MEETING NOTICE – VILLAGE BOARD (Regular)

Date/Time: Tuesday October 4th 2022 (6:00 P.M.)

A. INFORMATIONAL - New 11,890 square foot commercial building and associated site improvements (3828 Packerland Dr., HB-950-7) (Site Review Committee) (Page 16)

B. INFORMATIONAL - New 25,256 square foot commercial building and associated site improvements (4950 Founders Ter., HB-524-1) (Site Review Committee) (Page 46)

SITE PLAN

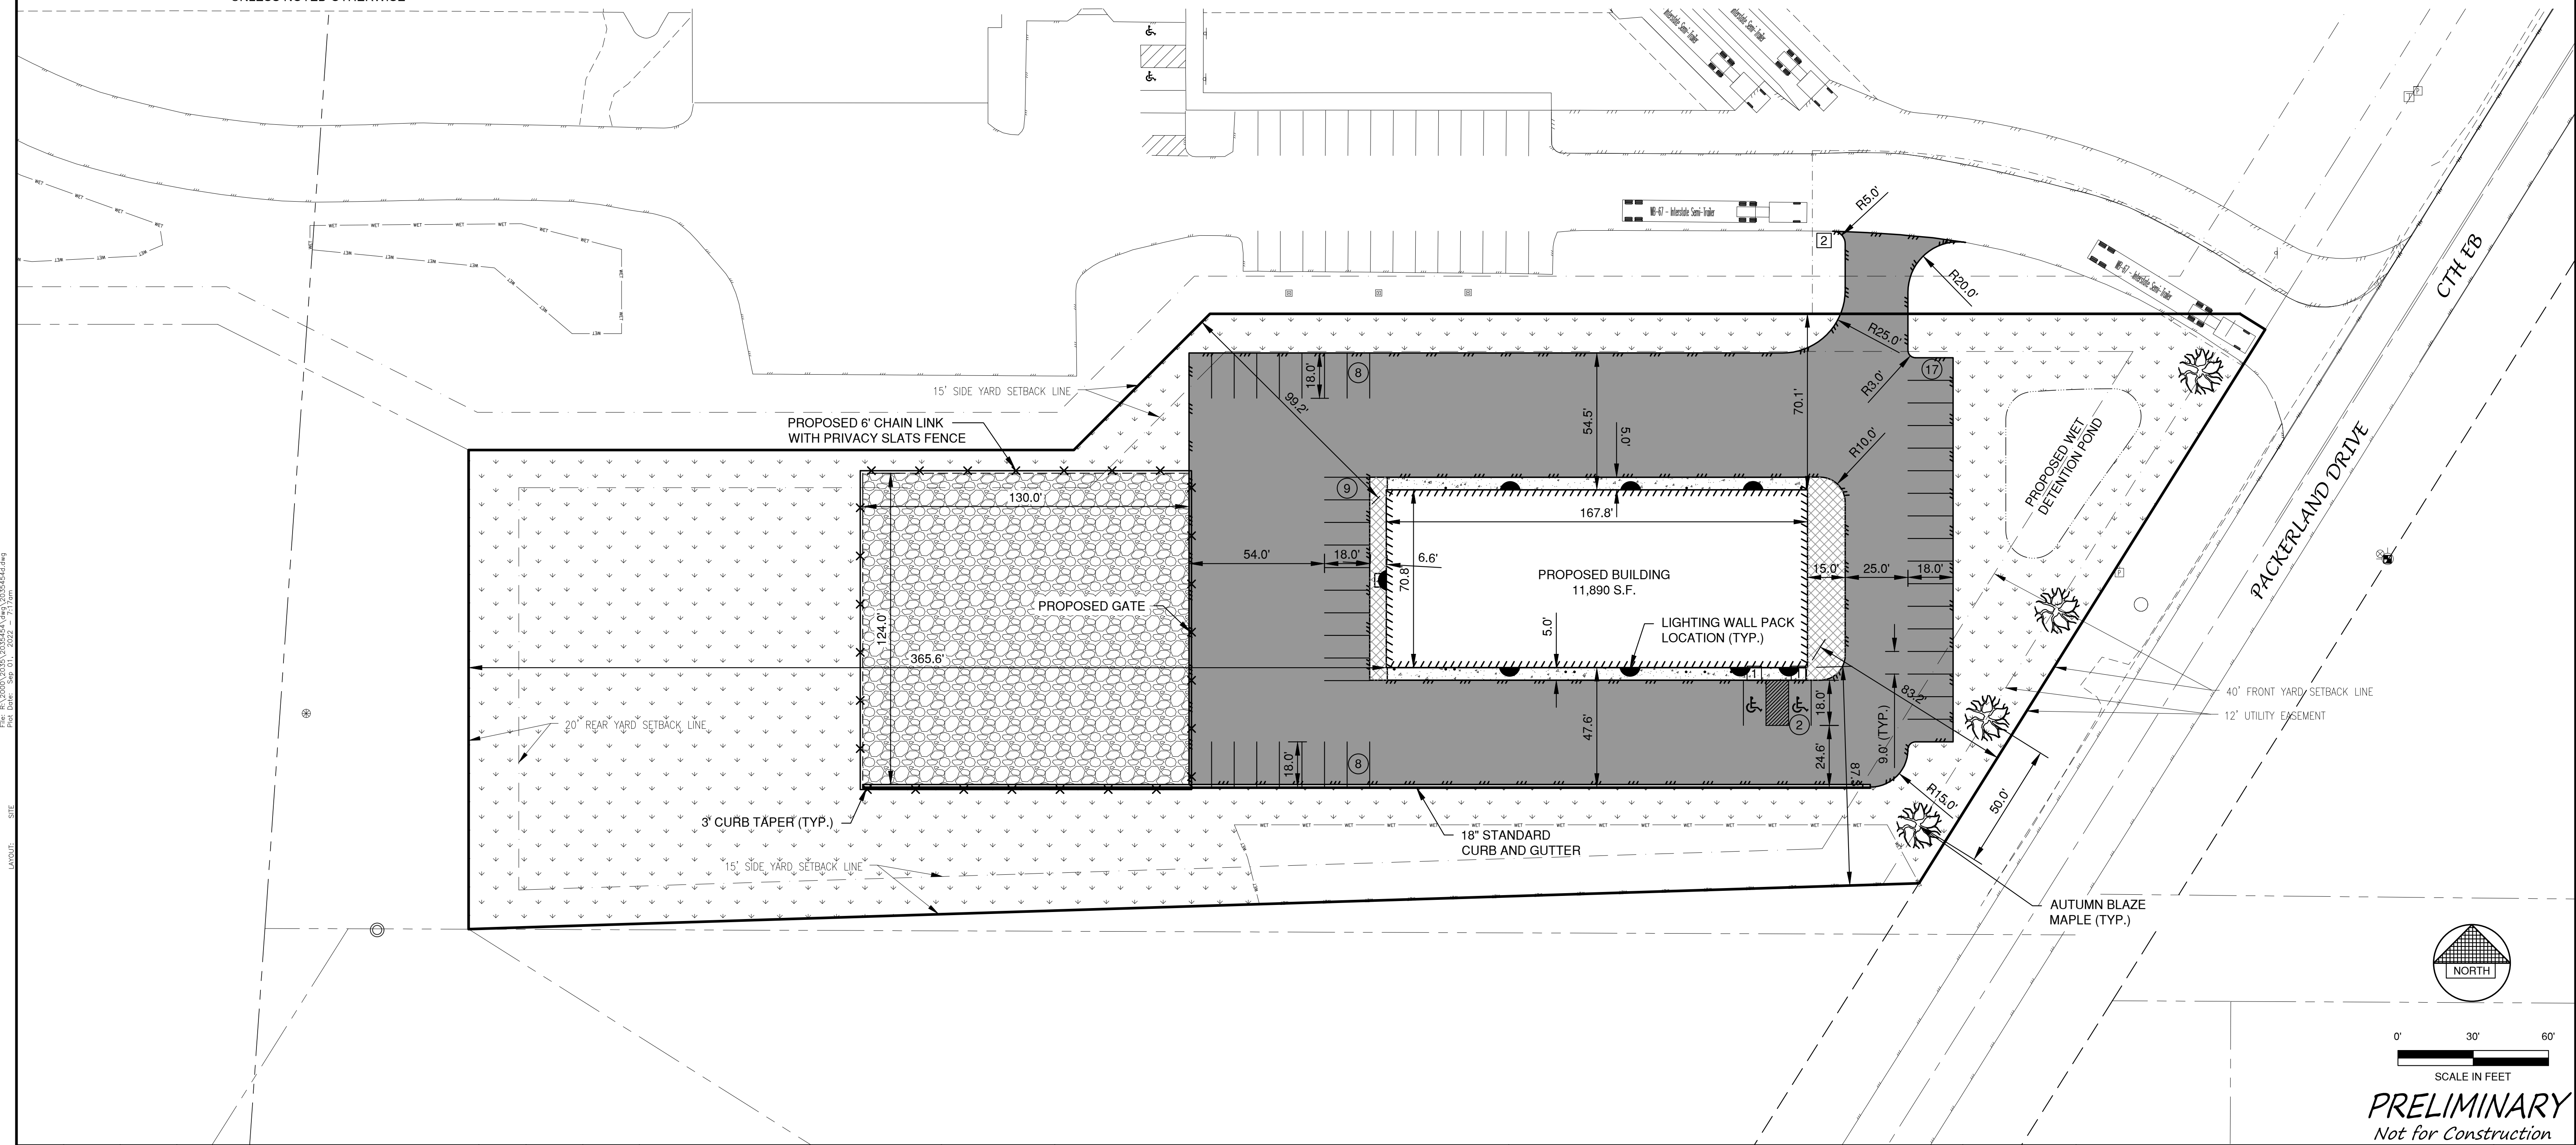
- A. **Zoning:** I-1: Limited Industrial District
- B. **Green Space:** 42.6% green space.
- C. **Setbacks:** Compliant with zoning district requirements. 40' front(s) (83' from Packerland), 15' side (70' from north property line), 15' side (87' from the south property line), and 20' rear (365' from the west property line).
- D. **Parking:** 44 spaces proposed, 40 are required. There is additional paved surface available for parking if so needed.
- H. **Fire Dept. (and Police Dept.):** The plans presented have been reviewed and accepted by the Police Department and Fire Department.
- I. **Storm Water:** Storm water will be collected by on-site storm sewer before discharging to an on-site wet pond on the east side of the development (along Packerland Dr.).

Section 5, Landscaping Plan: There are no plantings shown along the building foundation (front elevation) and the other three sides of the building will have hard surfaces adjacent to the building. The landscape plan has four (4) deciduous trees proposed along Packerland Dr., but a total of 5 trees are required to comply with the Village requirement of one (1) tree per 50 feet of road frontage.

Section 6, Lighting: No parking lot lighting is proposed at this time. Wall packs are proposed, and all proposed as noted on the plans.
